Public Service of New Hampshire

April 3, 1986
SBN-991
T.F. 7.1.99

Subject: Confirmatory Item C-21, "Routing of Off-Site Power Circuits,"
Additional Information on Guardrails

Additional Information on Guardrails
(Confirmatory Item C-21)

| | 9763-F-309826 | FIGURE 8-2-7 |

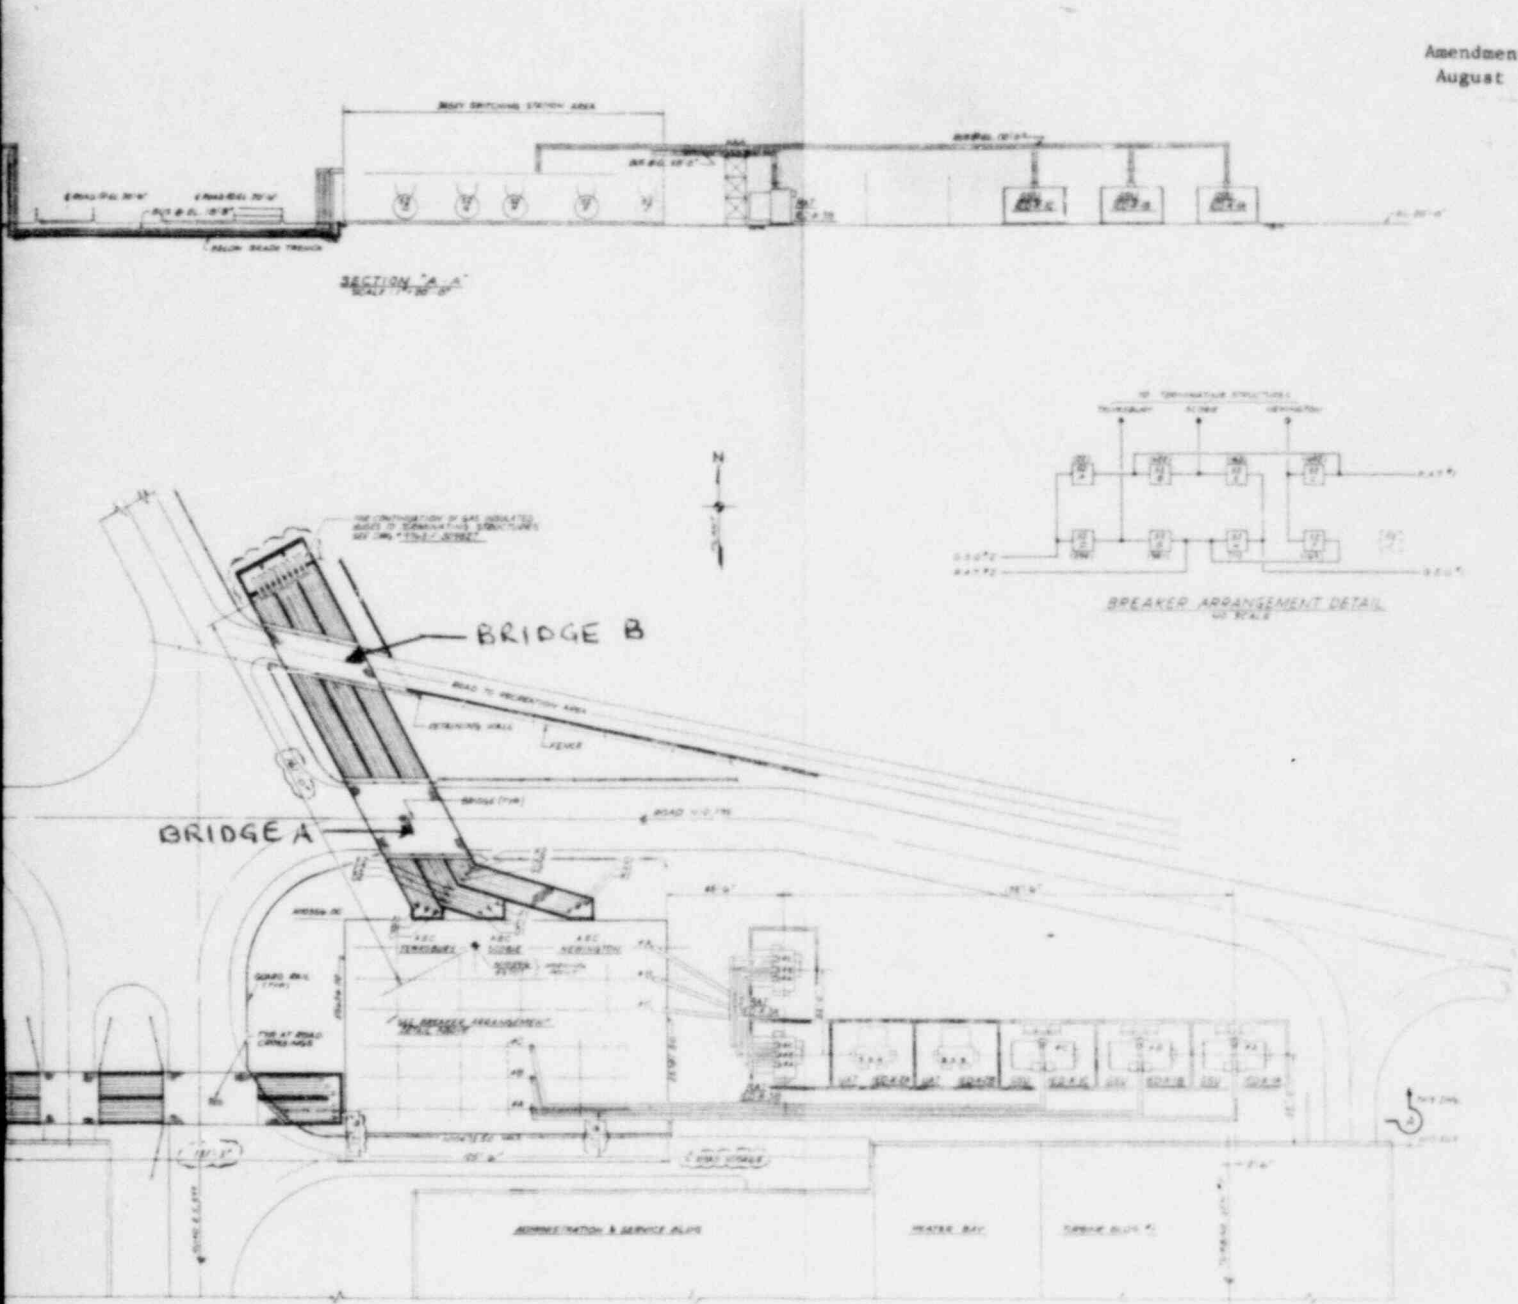
For the Seabrook design, the connection of these circuits from the transmission line terminating structures to the switchyard is done utilizing gas insulated (SF₆) metallic bus work; refer to FSAR Figures 8.2-7 and 8.2-8 (attached). As shown on these figures, the SF₆ bus work runs under two access bridges (Bridge A and Bridge B).

ELEVATIONS, POST AND BEAM GUARD RAIL

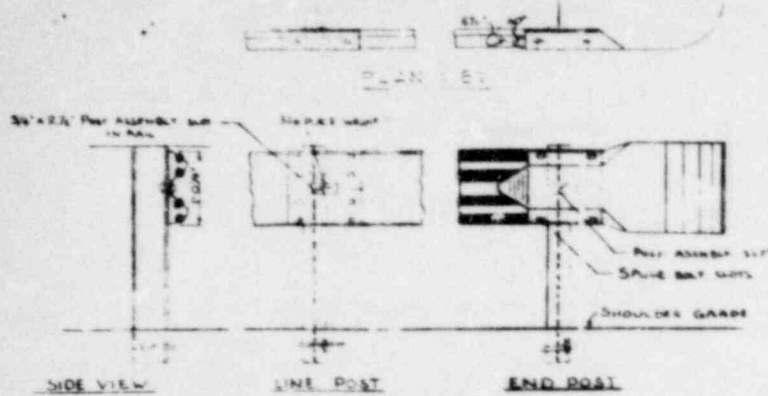
- (D) A galvanized steel protective grating is installed on top of the walls separating the SF₆ bus work. Refer to photographs for views of the grating. (End pieces of grating adjacent to the bridges have not yet been installed.)
- (E) Additional guardrails are provided as shown in Attachment A to guide access to the bridges. The design of this type of guardrail is as shown in Attachment B.

PHOTO (A)

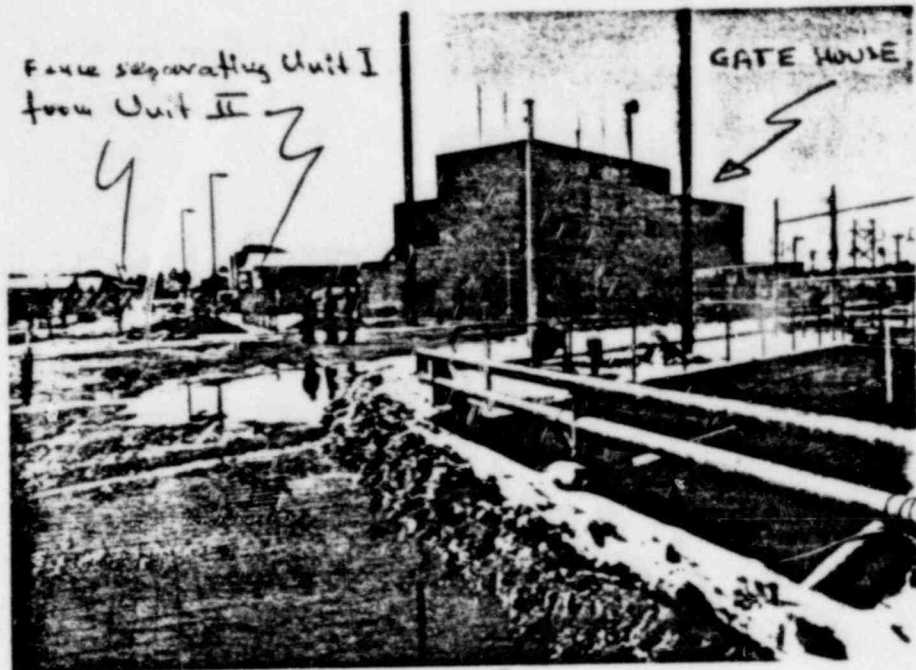
- (A) Vehicular traffic on these bridges is subject to strict plant-regulated speed limits: 15 miles per hour for Bridge A and five miles per hour for Bridge B. These speed limits will be posted and will be enforced by the plant's security forces located at the Gate House. Photograph A shows the proximity of the Gate House to the bridges. Because of this proximity, there is insufficient distance for a vehicle to accelerate to an unacceptable speed as it enters the site and proceeds towards Bridge A.

PHOTO (B)

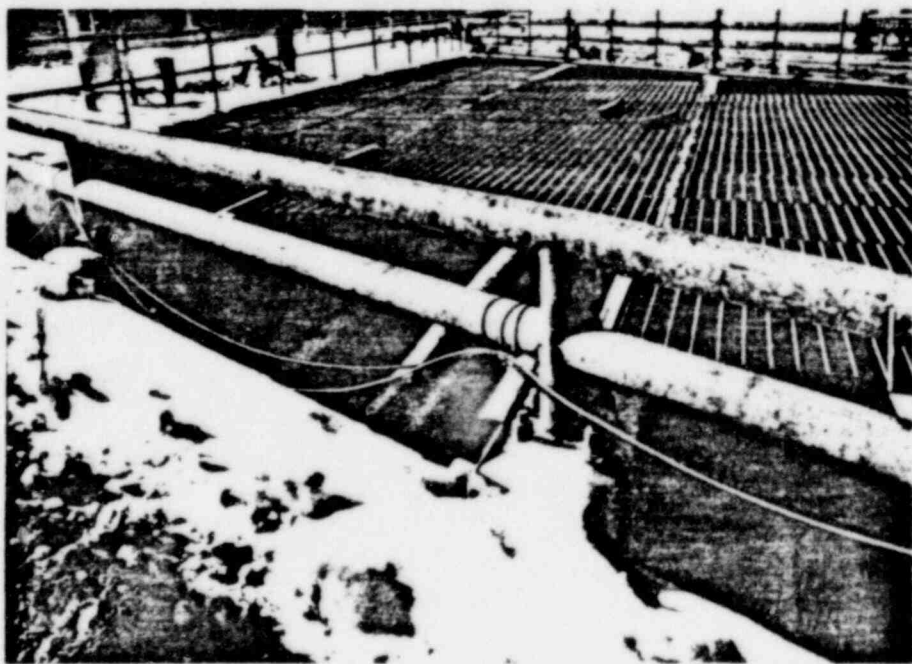
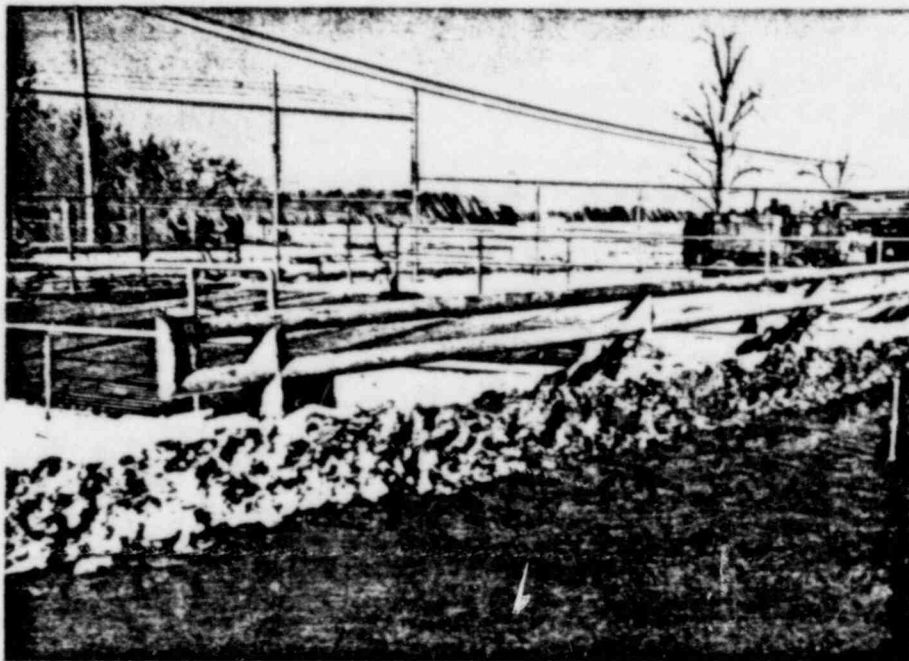
- (B) Heavy guardrails are provided on the bridges. (Refer to Photographs B and C.) These guardrails are designed and constructed in accordance with AASHTO (American Association of State Highway and Transportation Officials) requirements. Guardrails designed per these requirements have been successfully tested by AASHTO to sustain a 25° impact from a 4,500-pound car traveling at 60 miles per hour. For details of the design and material used for the guardrails, refer to UE&C Calculation SS-15.
- (C) Each SF₆ bus work constituting a circuit (three tubular buses per circuit) which runs under the bridges is in its own concrete compartment and is separated by the adjacent one by a one-foot thick concrete wall. Refer to Photographs D and E for details.

PHOTO (D)

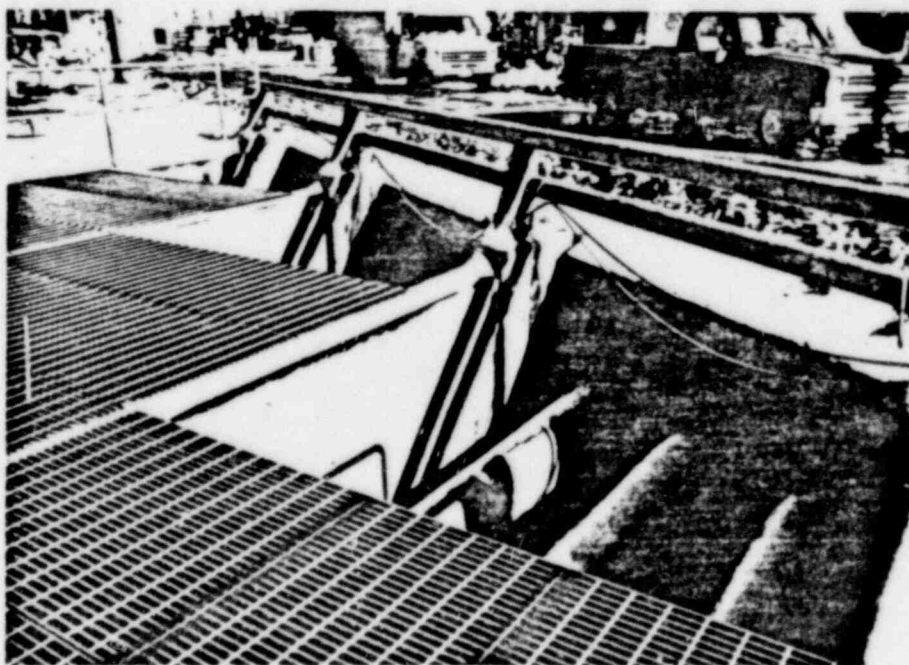
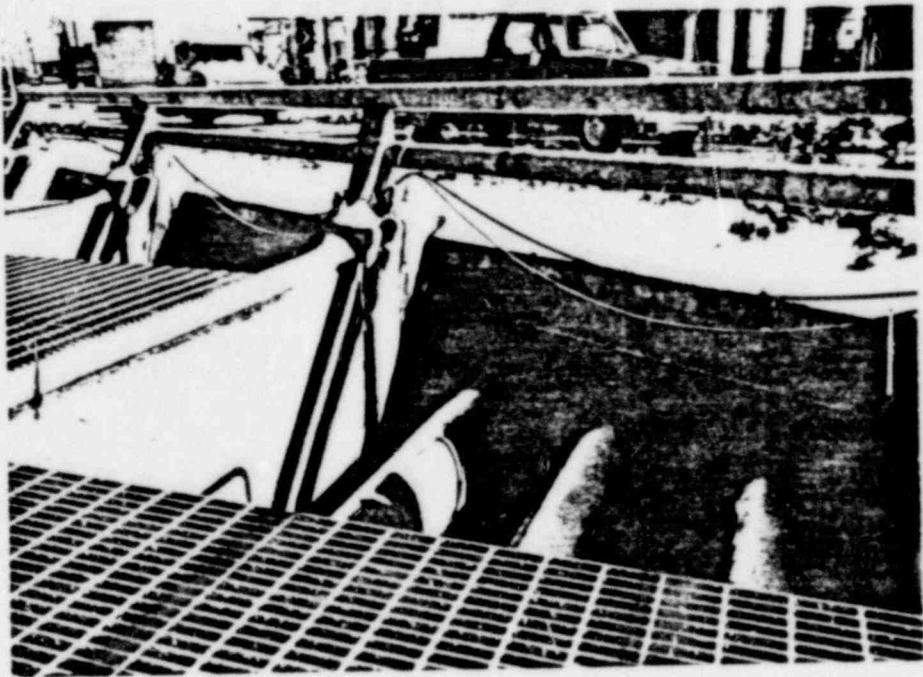
If the vehicle is not totally stopped by the impact on the guardrail, then the grating and the concrete walls separating the SF₆ bus work will further slow down the vehicle. As shown on Photographs D and E, the SF₆ bus work is located at the bottom of the concrete compartments, and there is at least a two-foot distance between the top of the tubular bus to the top of the concrete wall where the metal grating rests so that the vehicle cannot impact two circuits simultaneously.
